DOCKETED	
Docket Number:	24-BSTD-01
Project Title:	2025 Energy Code Rulemaking
TN #:	256224
Document Title:	Gary Klein & Nick Brown Comments - Heat Pump Water Heater provisions
Description:	N/A
Filer:	System
Organization:	Gary Klein & Nick Brown
Submitter Role:	Public
Submission Date:	5/7/2024 5:41:29 PM
Docketed Date:	5/8/2024

Heat Pump Water Heater provisions

From: Gary Klein, Gary Klein & Associates and Nick Brown, Build Smart Group

FIGURE 12. HPWH EFFICIENCY IN ENCLOSED SPACES

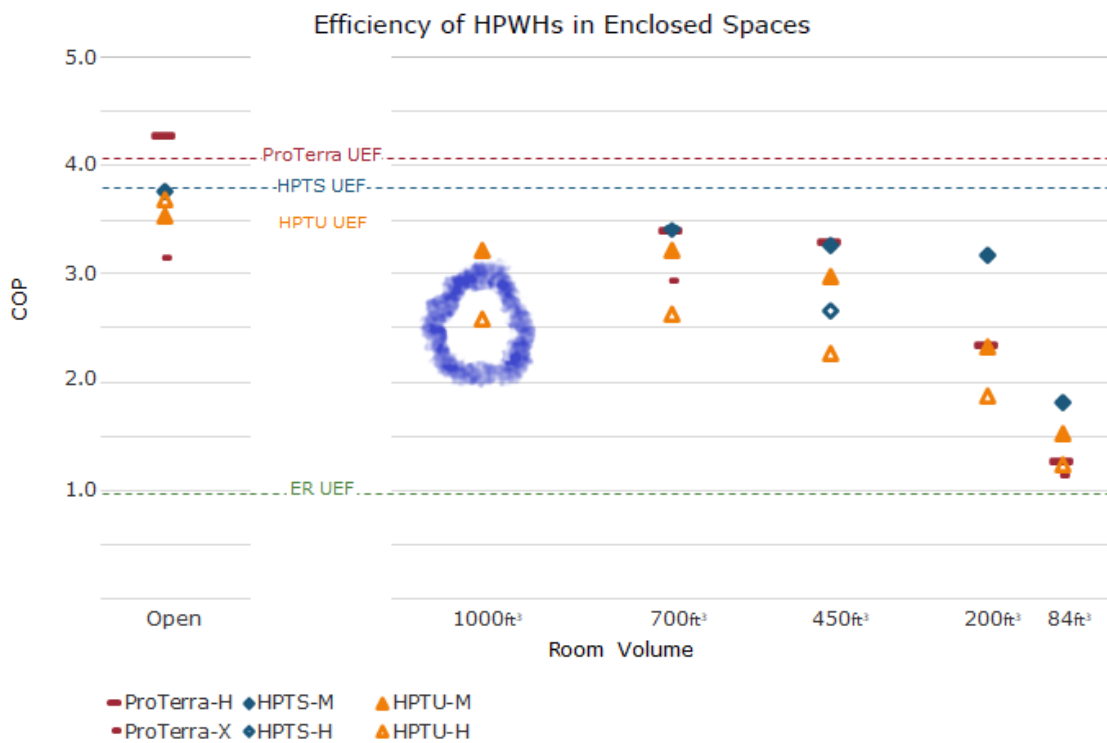
We calculate that the minimum space volume that has been proposed is insufficient; and the space required without access to external air likely needs to be significantly above 250 cubic feet per kBtu/hr in order for the HPWH to operate primarily in heat pump mode, rather than resistance mode. This is based on Larsen and Gantley's report "Laboratory Testing of Heat Pump Water Heater Performance: Impact of Airflow and Space Configurations" sponsored by PG&E, December 2023. The circled data point for the AO Smith unit with high draw pattern (85 gallons per day) shows COP of 2.5 at 1,000 cubic feet with a 4,000 btu/hr heat pump. Any enclosed space reduces the COP. The higher the draw pattern in an enclosed space, the lower the COP in heat pump mode, until eventually, the hybrid HPWHs switch to resistance mode with a COP of 1. A key reason for the lower efficiency is that as the intake air for the heat pump gets colder, it is harder to extract energy from the air. Hence, we propose the 250 cubic feet per kbtu/hr minimum requirement to allow for high draw patterns in enclosed spaces. Note that this allows for installation in one-car garages for typical hybrid HPWHs and in two-car garages for 12kbtu/hr HPWHs, without added ventilation in either of these two spaces.

An unintended consequence of enclosed spaces is to limit the amount of hot water that can be made in heat pump mode. This is due to two factors: how much energy can get into the room via conduction only and how many hours the HPWH can operate in heat pump mode inside this room.

Again, referencing the Larsen/Gantley report, for every 2 hours the HPWH runs in heat pump mode, the room takes at least one hour to recover the heat that has been extracted. And this was based on the space surrounding the enclosed room always being warmer, so heat could flow inwards via conduction, implying that this only works when the HPWH is installed inside a conditioned envelope. This means that the heat pump can only run 16 hours out of every day.
